MEMO

TO: City Council
DATE: December 14, 2018
FROM: Anita McNamara, Development Services
RE: **Hillview Crossing TED Conditional Use**

On Wednesday, December 12, 2018 the Land Use and Planning Committee discussed the Hillview Crossing Townhome Exemption Development Conditional Use as a pre-public hearing information item. Council member questions and associated answers are provided below:

FIGURE D103.1
DEAD-END FIRE APPARATUS ACCESS ROAD TURNAROUND

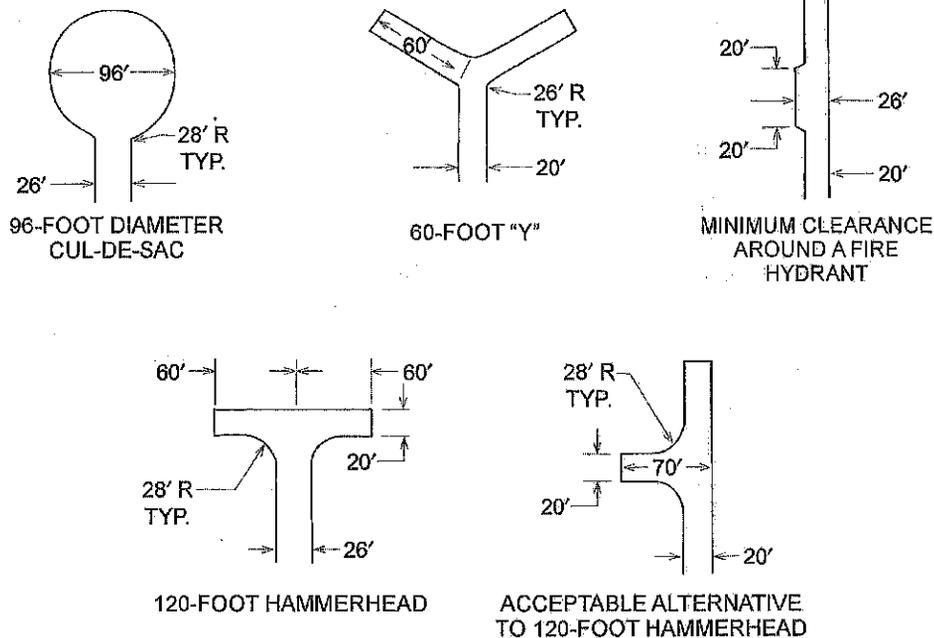
3. What are the Fire Code design requirements for hammerhead turnarounds? Is there a diagram?
 - a. City Fire provided comment that the Hammerhead turnarounds are acceptable, provided that the measurements are consistent with Appendix D (Fire Code for Fire Apparatus Access Roads) of the International Fire Code (attached as Exhibit #1).

- b. City Fire provided comment that the proposed private roads within the Hillview Crossing TED meet the minimum requirements of the Fire Code. City Fire comments are attached to the SIRE record. Further City Fire commented that emergency traffic on private roads like this that have slope and are narrow is slow with optimal conditions. If the parking prohibitions are enforced and snow removal is provided, emergency vehicles access meets the minimum requirements.

- c. City Fire also commented that if the hydrants are located on the No Parking side of the road, the private road width would need to be expanded to 34 feet in width for the portion of the road near the hydrant so that fire apparatus does not block a travel lane.

Surrounding Land Densities & Lot Sizes

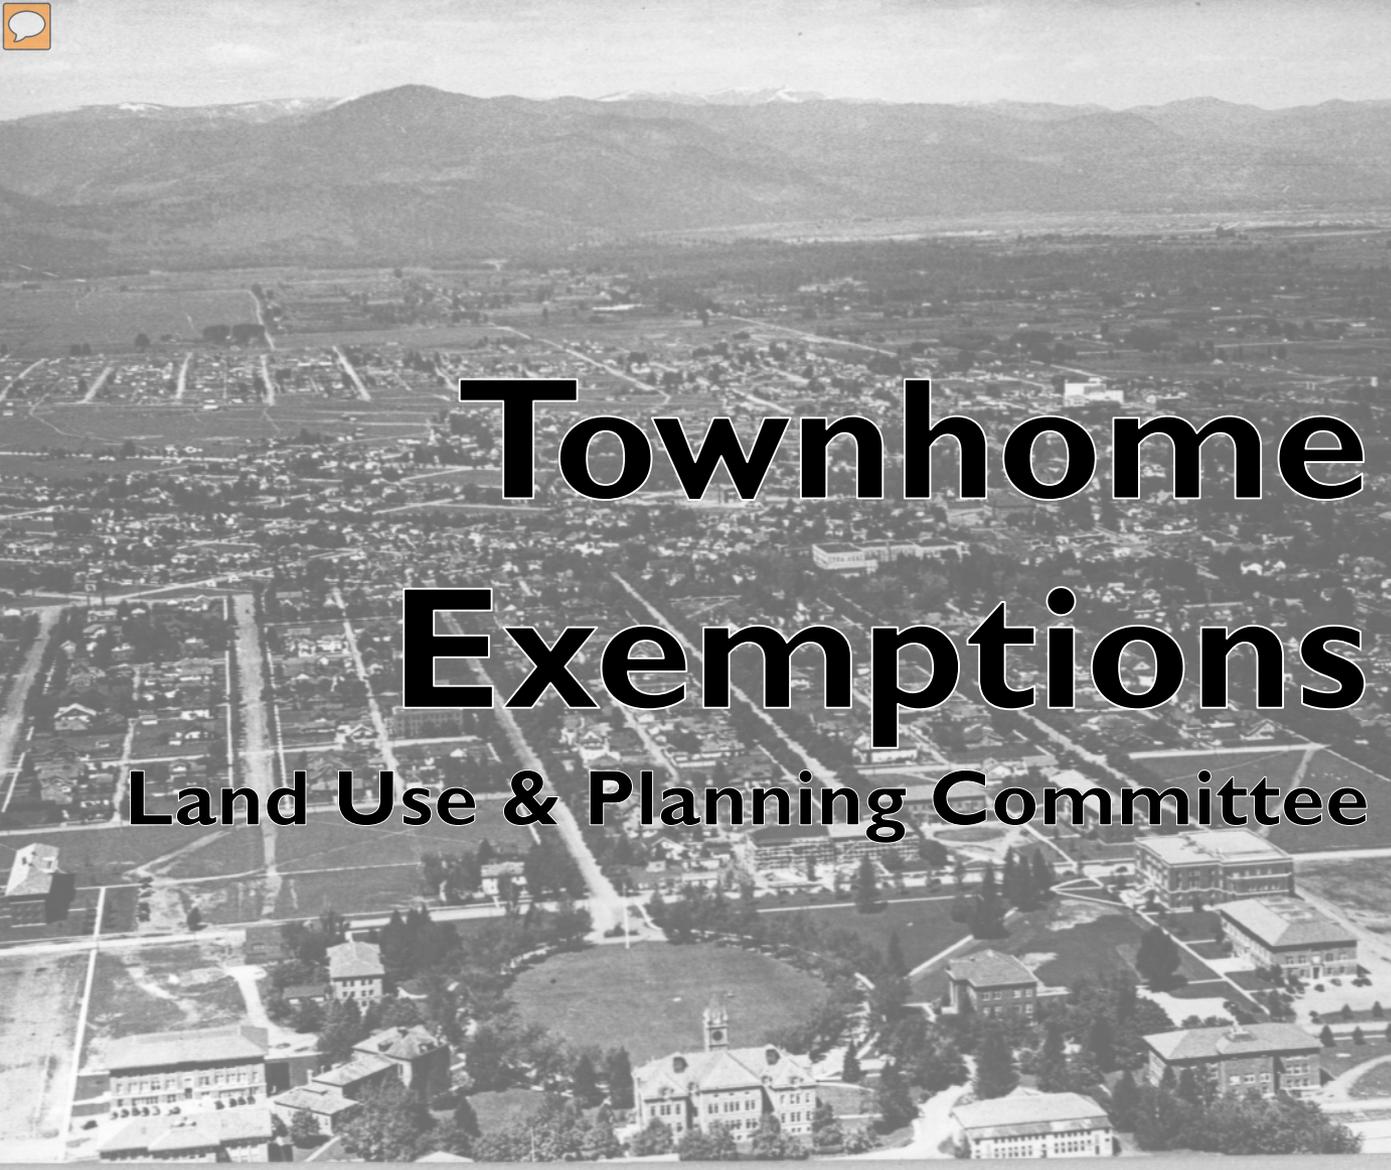
- J. What are the densities of the surrounding development?
 1. Staff has provided a map that shows densities of development surrounding Hillview Crossing TED in Exhibit #3 and the map will be included in the staff presentation at the public hearing.
